1. The Draft DCO and Other Consents

Question No.	To	Question	Response
1.1.23	All parties with protective provisions for their benefit included in Schedule 16 (Protective Provisions) of the dDCO.	Please provide an update on discussions regarding protective provisions, identifying any outstanding areas of disagreement.

Sheet 4:

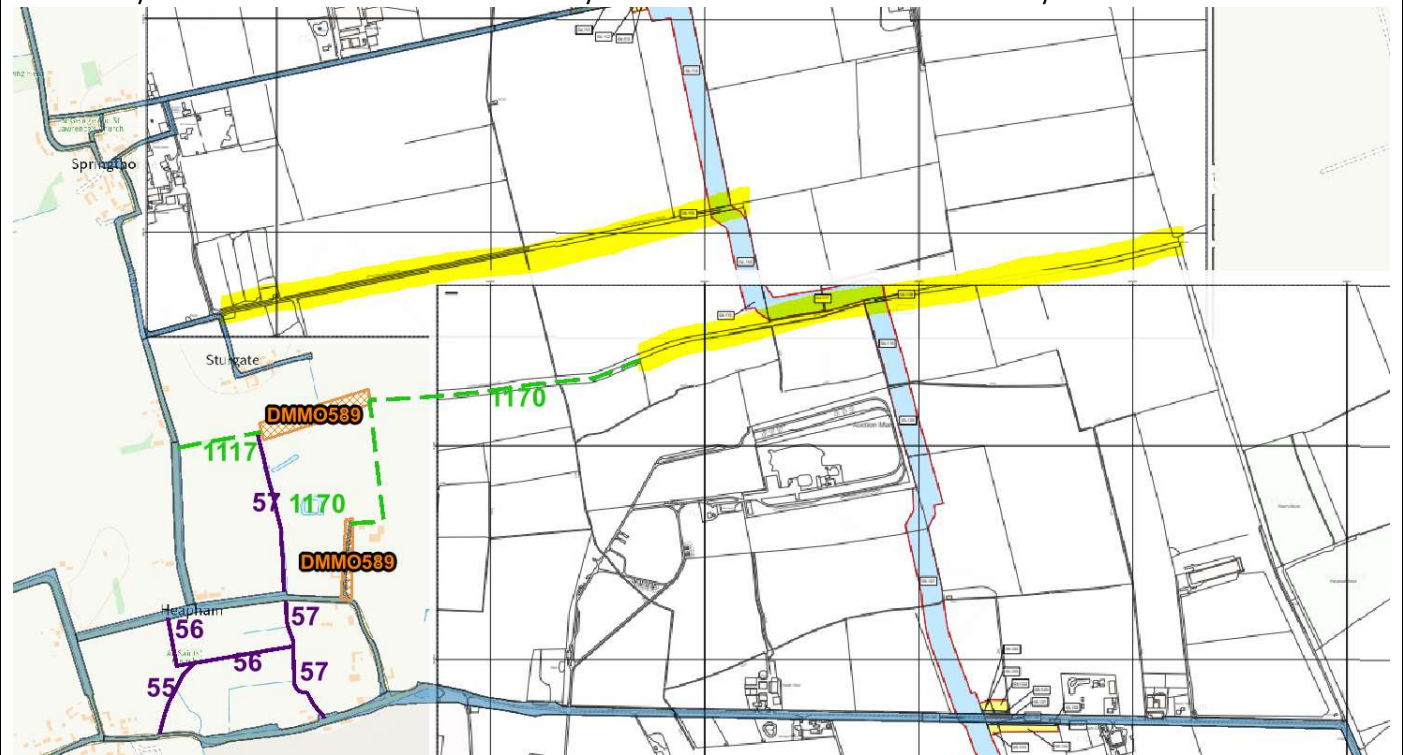
Potential unrecorded PROW east of Sturgate which potentially could be claimed in the future; No applications have been received regarding these at present however we are aware that an applicant who has been prolific in submitting historic claims has yet to examine this section of the County so there is a risk that further claims may be received here.

Sheet 6:

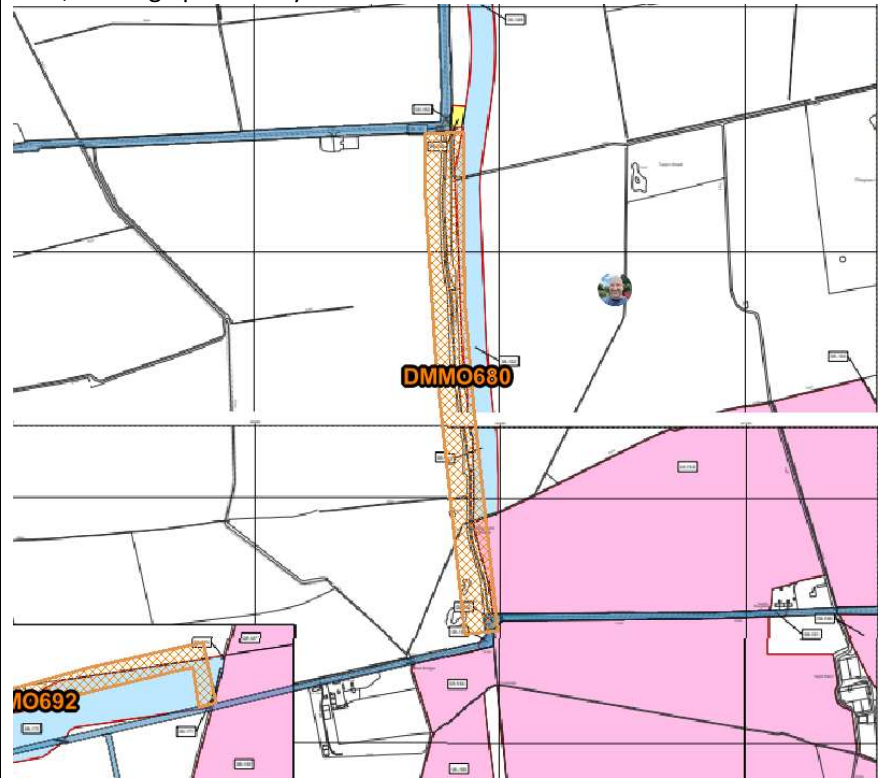
Claimed RB from Glentworth Road to Fillingham Lane - DMMO680 potentially might intersect with the planned works area, although probability is that it is to the west.
